HISTORIC AND DESIGN REVIEW COMMISSION

May 15, 2019

HDRC CASE NO: 2019-256
ADDRESS: 204 GORMAN ST
LEGAL DESCRIPTION: NCB 2871 BLK M LOT E 14 FT OF 8 & W 36 FT OF 9
ZONING: R-6
CITY COUNCIL DIST.: 2
DISTRICT: Dignowity Hill Historic District
APPLICANT: Armando Montelongo
OWNER: Reti Properties LLC, Armando Montelongo/Reti Properties, LLC
TYPE OF WORK: Porch column replacement, installation of porch railings, porch repair
APPLICATION RECEIVED: April 22, 2019
60-DAY REVIEW: June 21, 2019
CASE MANAGER: Edward Hall

FRONT

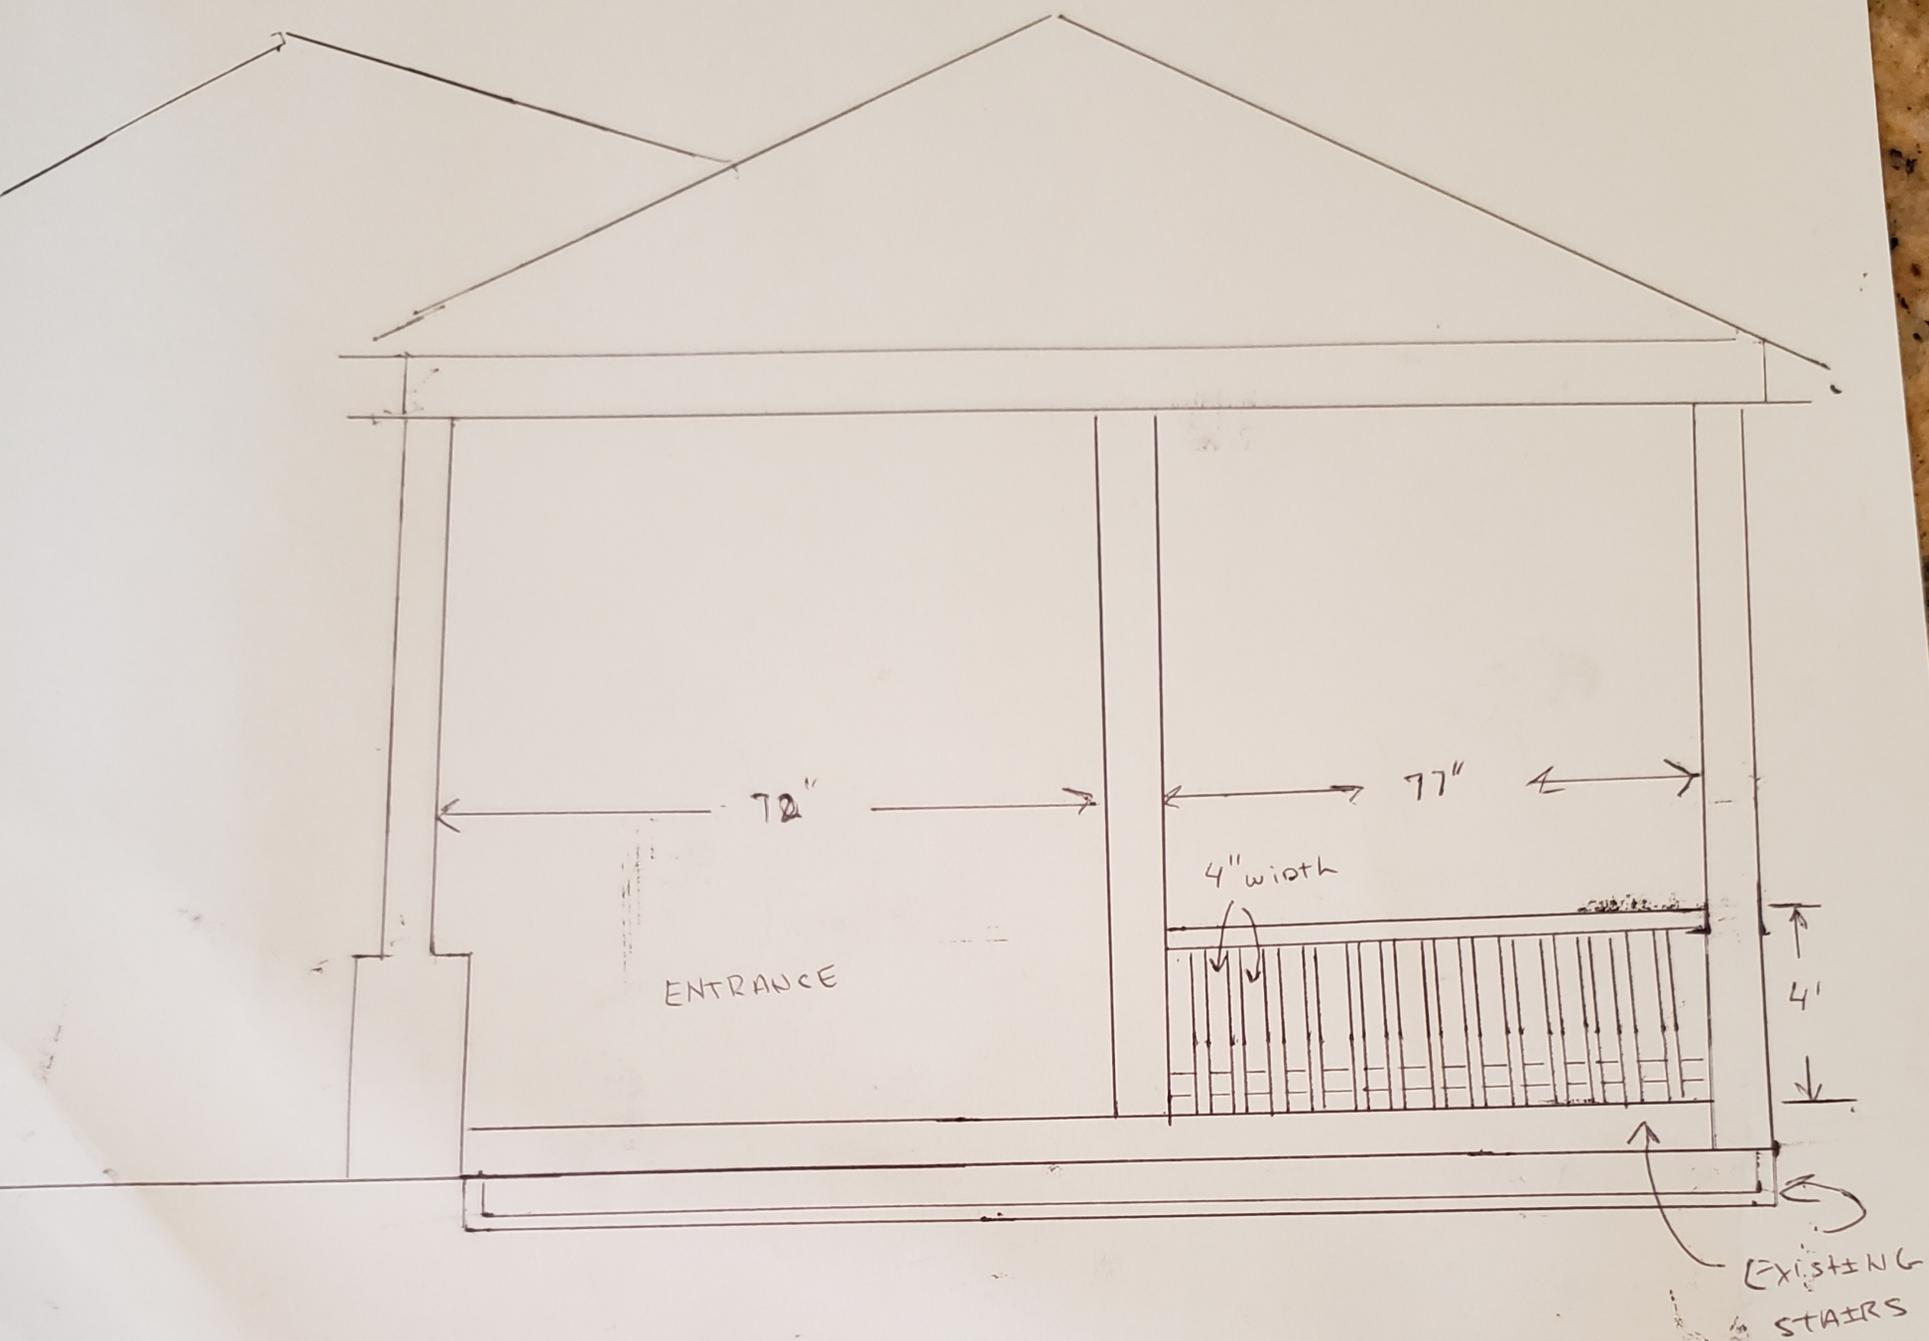
- b. **PORCH COLUMNS** – The applicant has proposed to repair the existing, non-original porch columns. Currently, there is one porch column that is original to the house. The existing columns consist of 4” x 4” posts. Staff finds that the if the removal of the existing, non-original columns is required, that the applicant install porch columns that match the original in profile and design.

- c. **PORCH RAILINGS** – The applicant has proposed to install porch railings that are to feature four (4) feet in height and feature spacing of four (4) inches between pickets. Staff finds the installation of porch railings to be appropriate; however, staff finds that the porch railings should be simple in design as to not appear original. The proposed railings should feature both a top and bottom rail. The bottom rail should feature a vertical orientation and should be installed approximately three to four inches above the porch decking. Both top and bottom rails should be constructed from 2”x4” members. The proposed railing should not feature an overall height of more than three (3) feet.

- d. **PORCH CEILING** – The applicant has proposed to install a porch ceiling of beadboard to replace the existing, non-original ceiling. Staff finds this to be appropriate and consistent with the Guidelines.

1. Staff recommends approval of item #1, porch columns repair with the stipulation that if the existing columns are replaced that they be replaced with columns that match the original in profile and material.
2. Staff recommends approval of item #2, porch railing installation with the following stipulations:
 - i. That the porch railings should be simple in design as to not appear original. The proposed railings should feature both a top and bottom rail. The bottom rail should feature a vertical orientation and should be installed approximately three to four inches above the porch decking. Both top and bottom rails should be constructed from 2”x4” members. The proposed railing should not feature an overall height of more than three (3) feet.
3. Staff recommends approval of item #3, porch ceiling replacement as submitted.
